President and Board of Trustees
Village of Arlington Heights
Board Room

October 19, 2015

Item: Ordinance - Chapter 28 Variation - Holy Nation Presbyterian Church

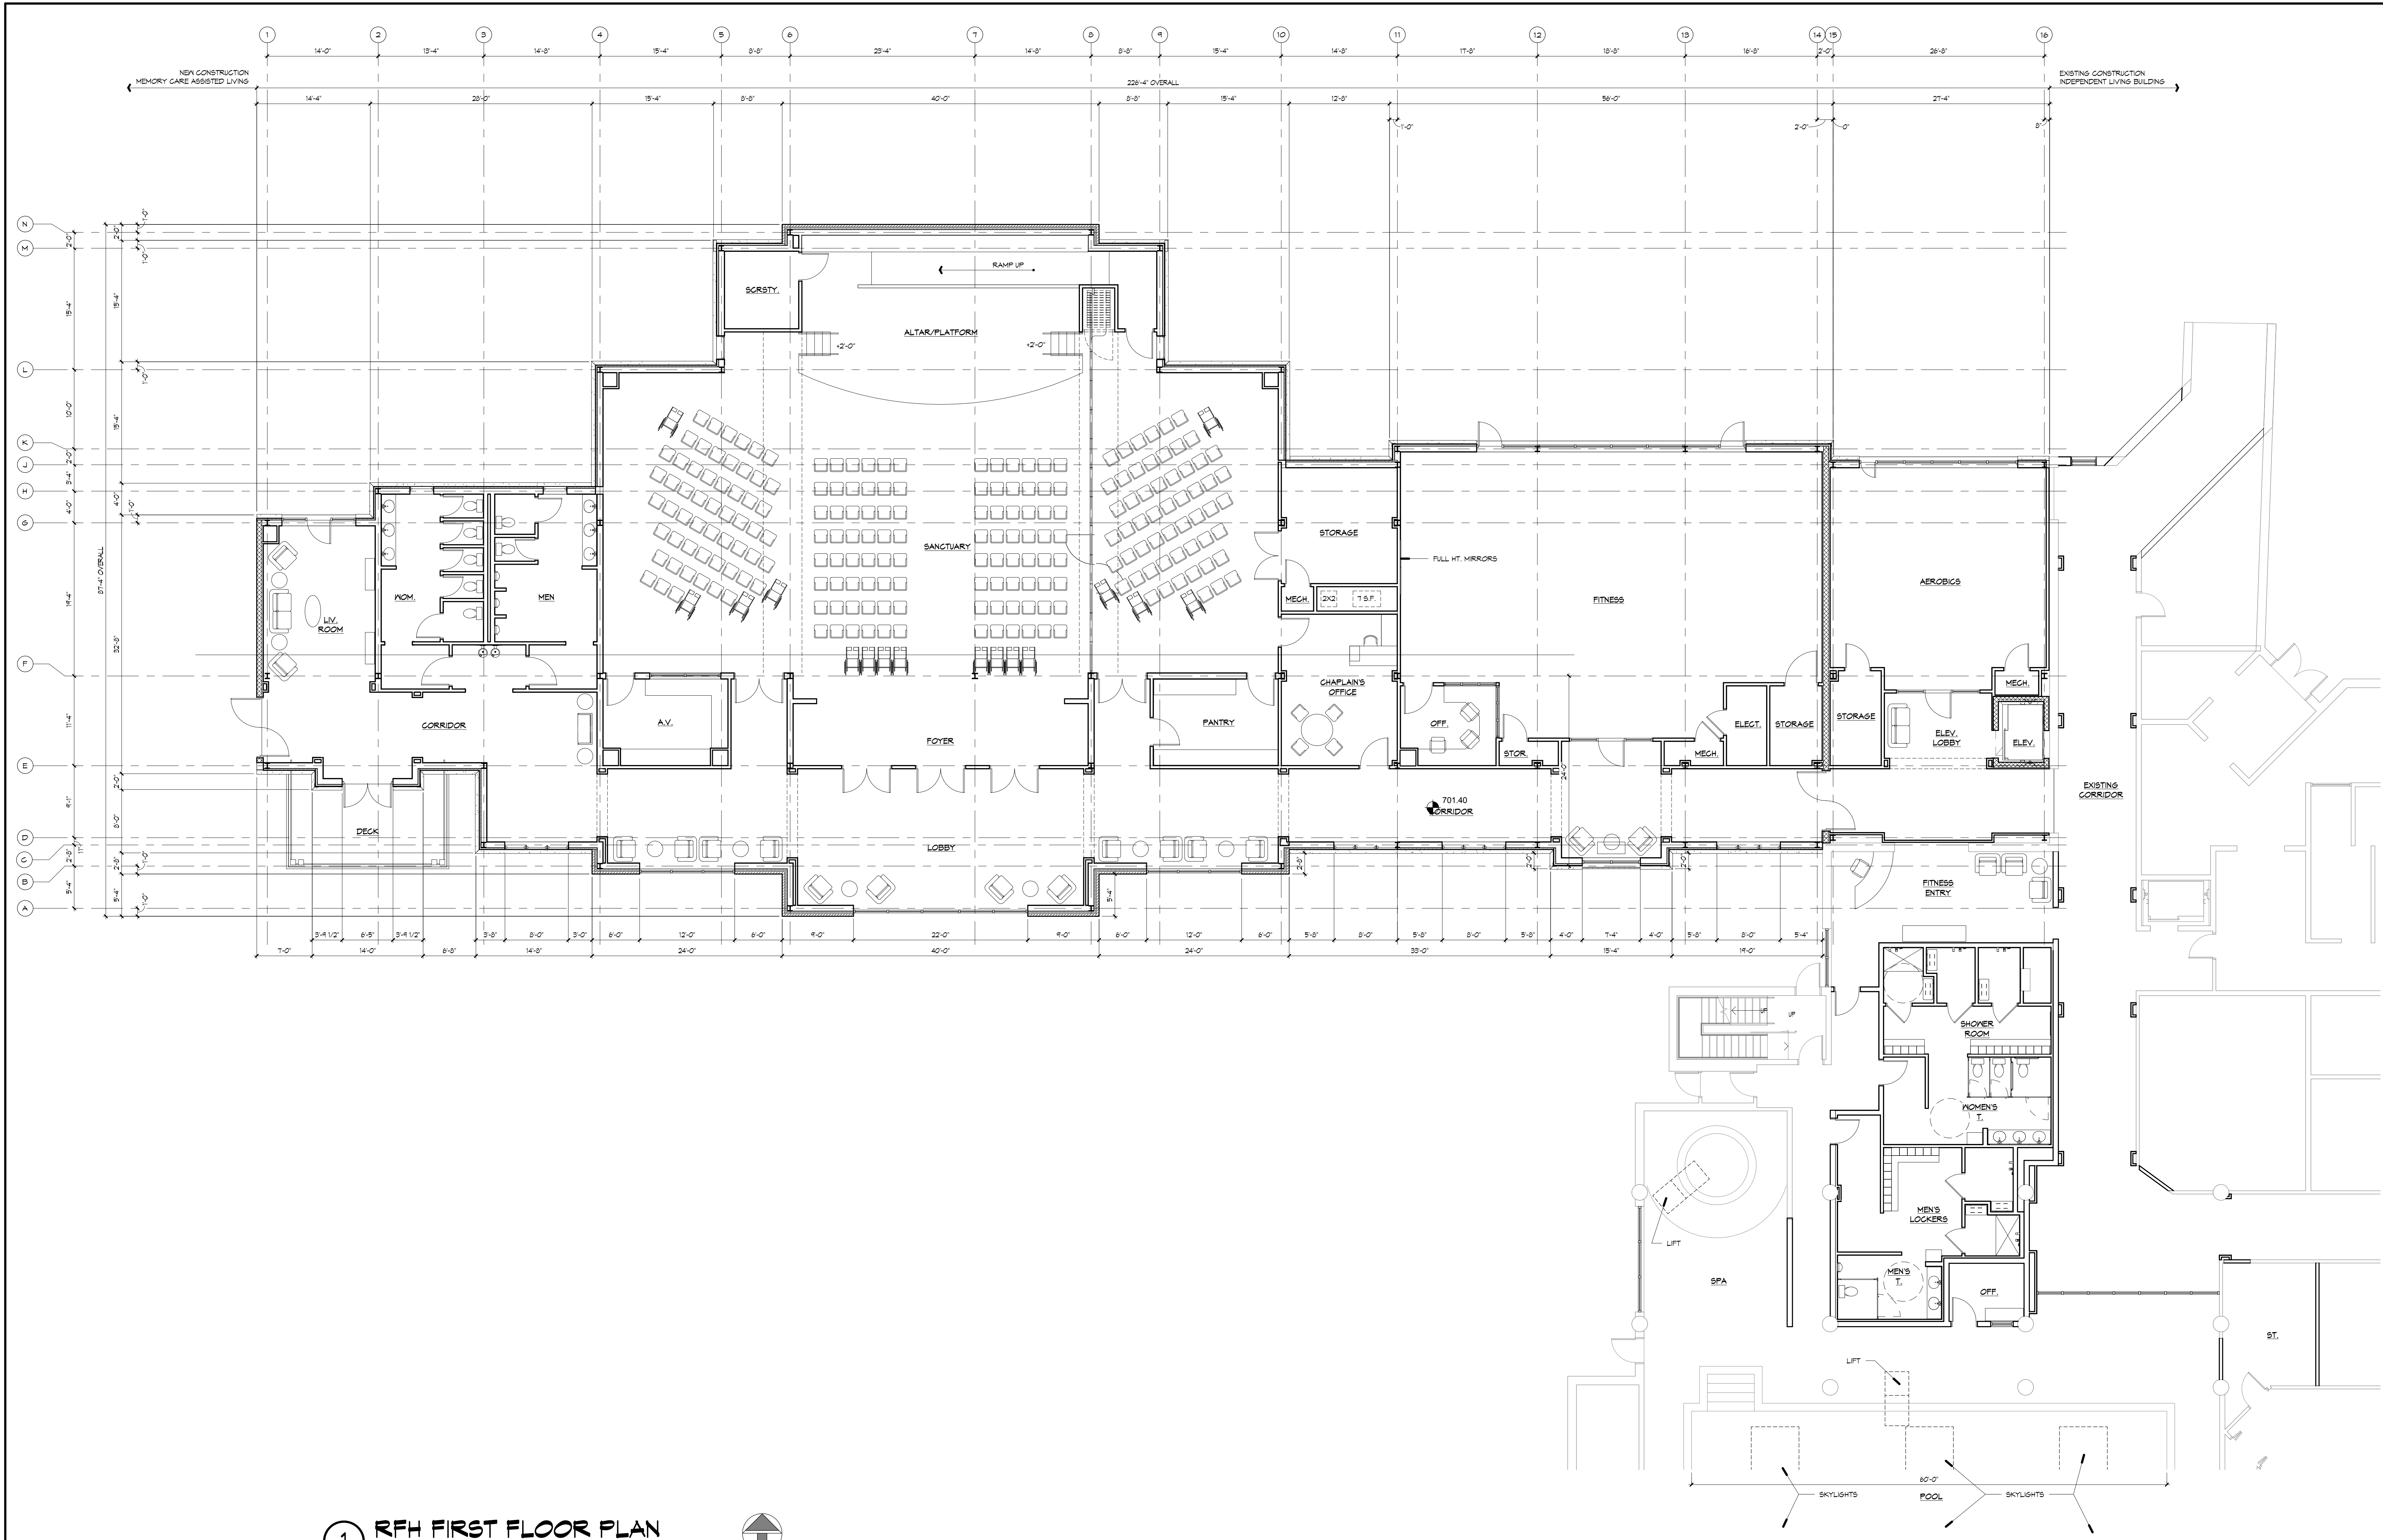
2. In the Men's and Women's Toilet Rooms the wheelchair accessible "Standard Stall" door shall open opposite the clear floor space to allow adequate wheelchair maneuvering space within the stall, per IAC Section 400.Illustration B. Figure 30(a).

1. The plans have been modified to to provide required clearance. See attached Resident Fellowship Hall drawing A101.
2. The stalls have been modified to provide required clearances. See attached Resident Fellowship Hall drawing A102.
3. The stalls have been modified to provide required clearances. See attached Assisted Living drawing A101.

TREE SURVEY /
PRESERVATION
PLAN

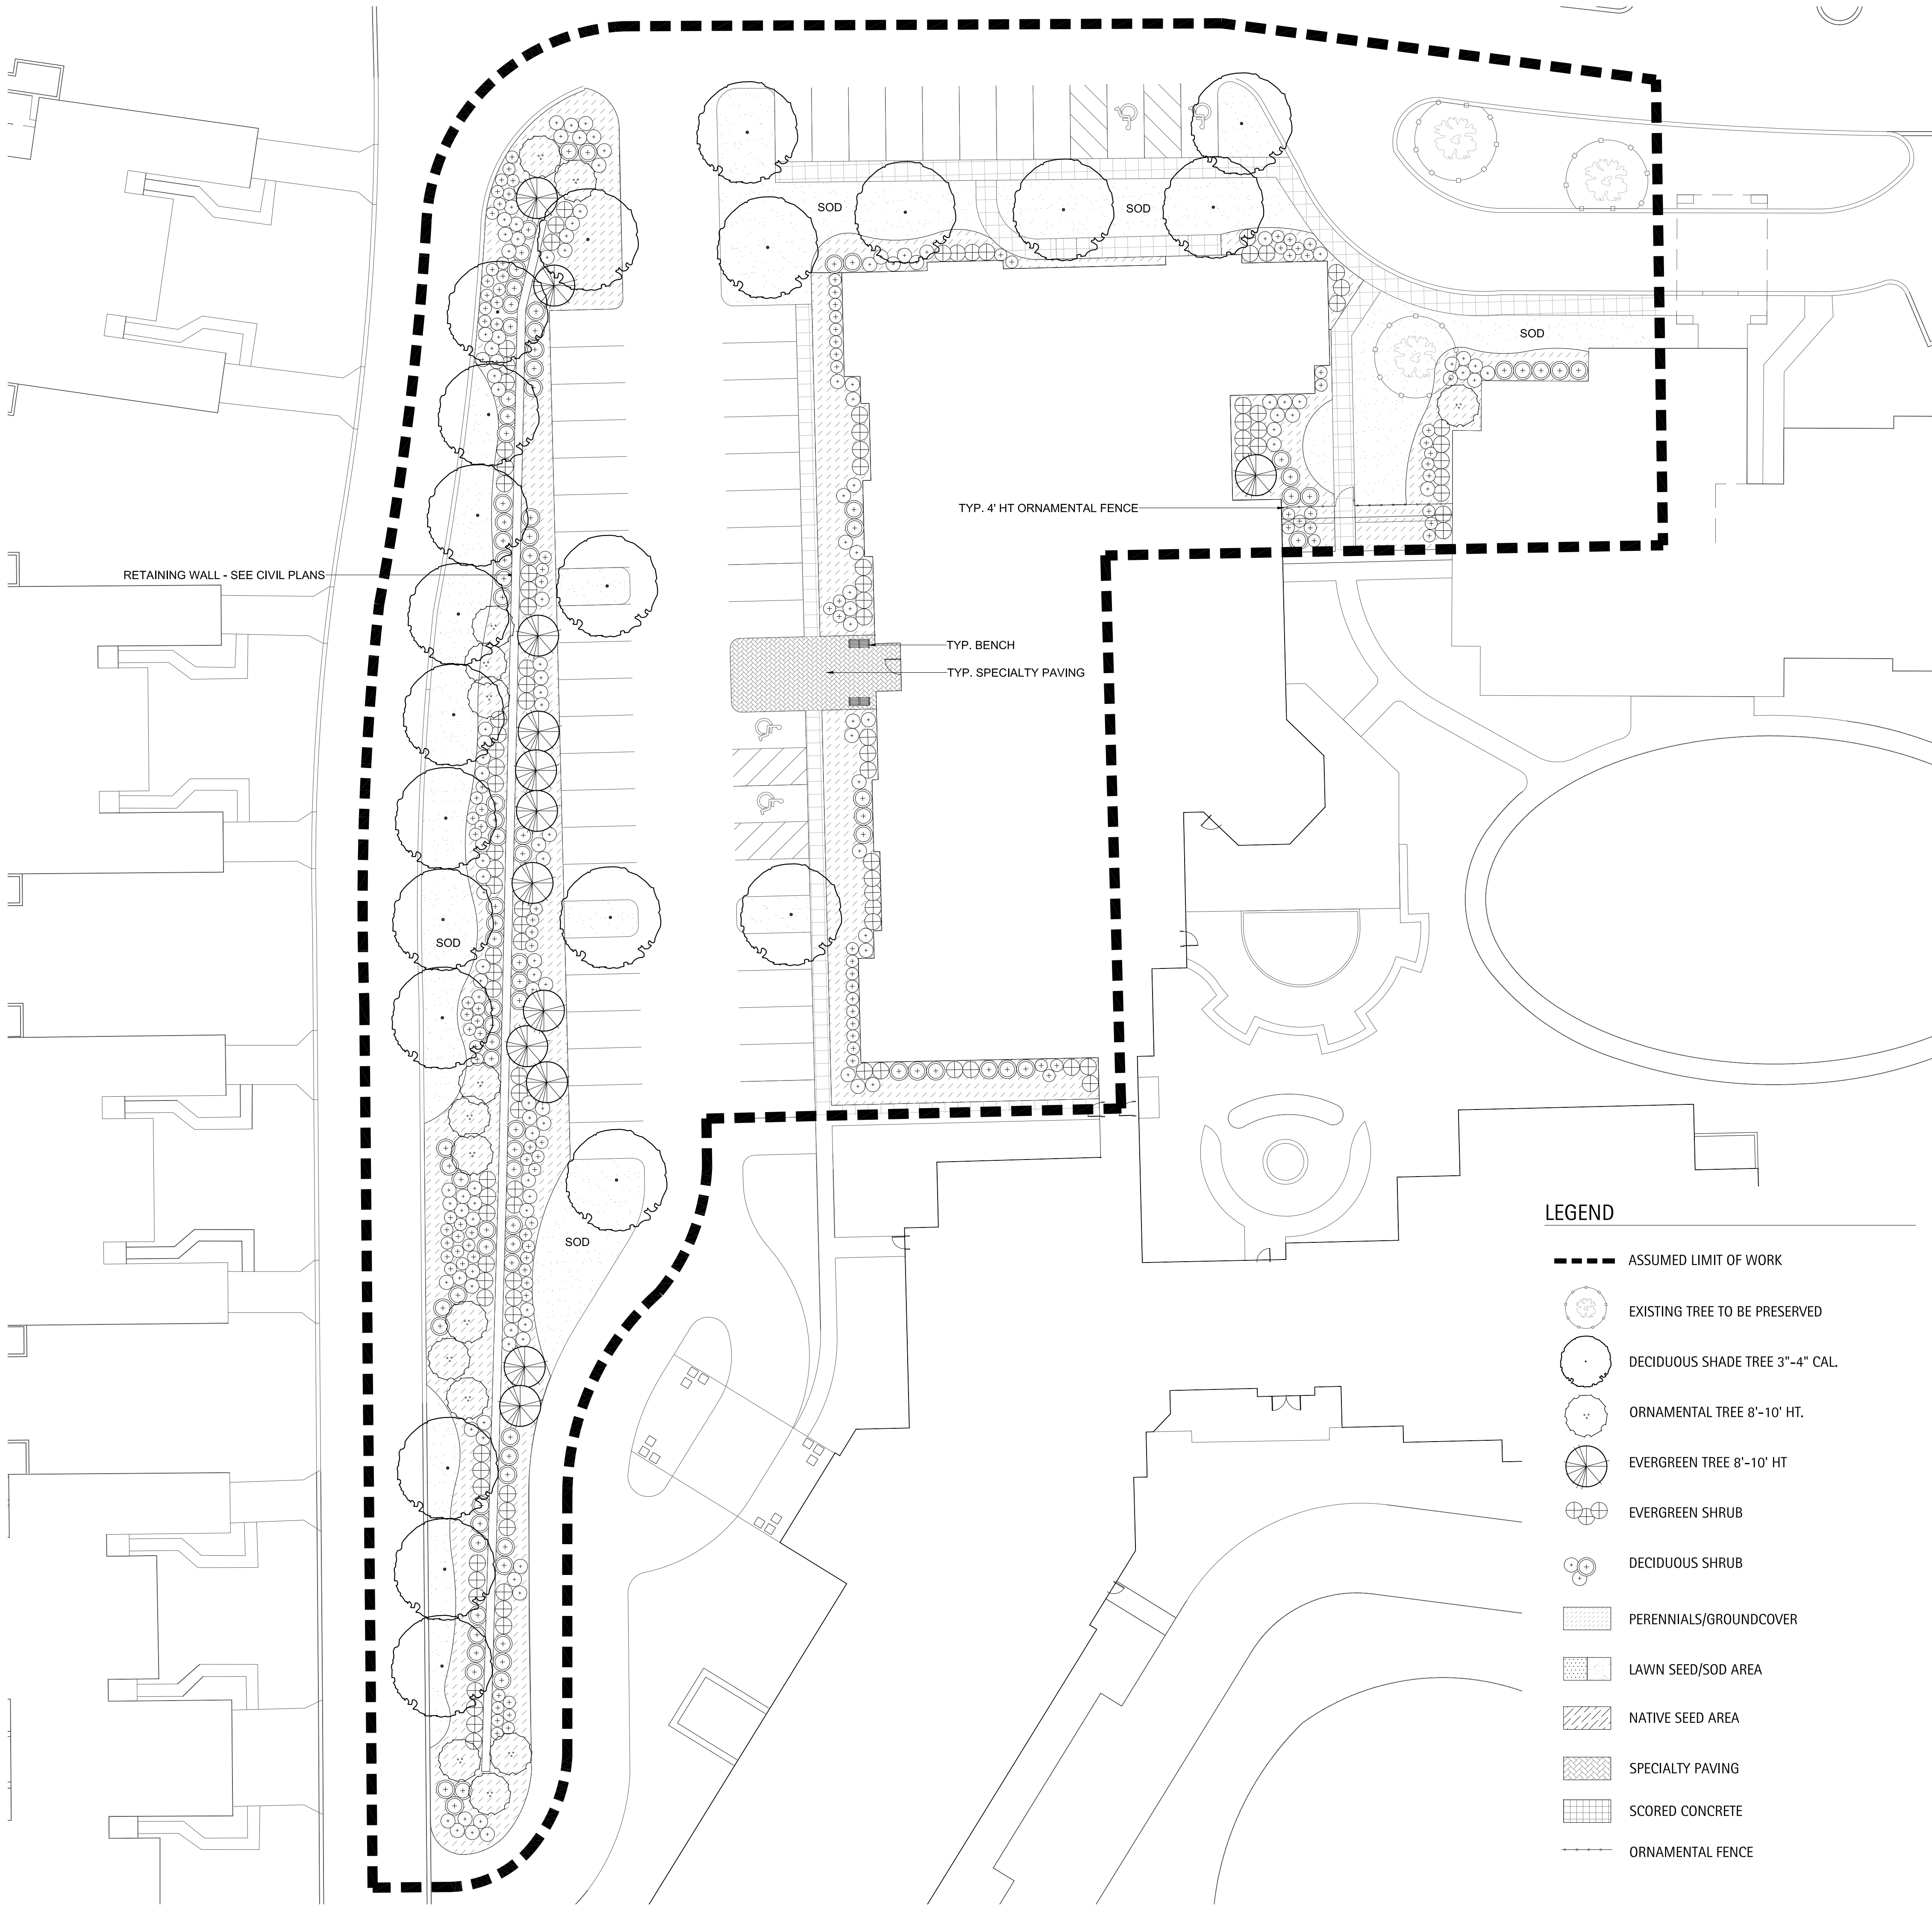
- 1) Approximately 164 trees on the site are identified for removal. On the tree inventory on sheet L-01 please include the disposition for each tree. Also, on the plan increase the size of the tree number/tag so that it is legible.
- 2) Are there additional trees that could be preserved? It is recommended that additional trees be preserved adjacent to west lake and near the court yard (Zone B - Fellowship Hall). Please reevaluate the trees proposed for removal. Also, explore options for transplanting some of the trees elsewhere on the site.

- Sheet L-01 has been updated to reflect requested changes.
- While most of the trees planned for removal fall within new building/paving/wall or retention pond areas, some additional trees outside of these areas may require removal due to proposed site grading. Opportunities for preservation of additional trees will be further evaluated as civil engineering and grading plans are refined through the design development and construction documentation process. Identification of potential transplants will also be explored during subsequent refinements to landscape plans.
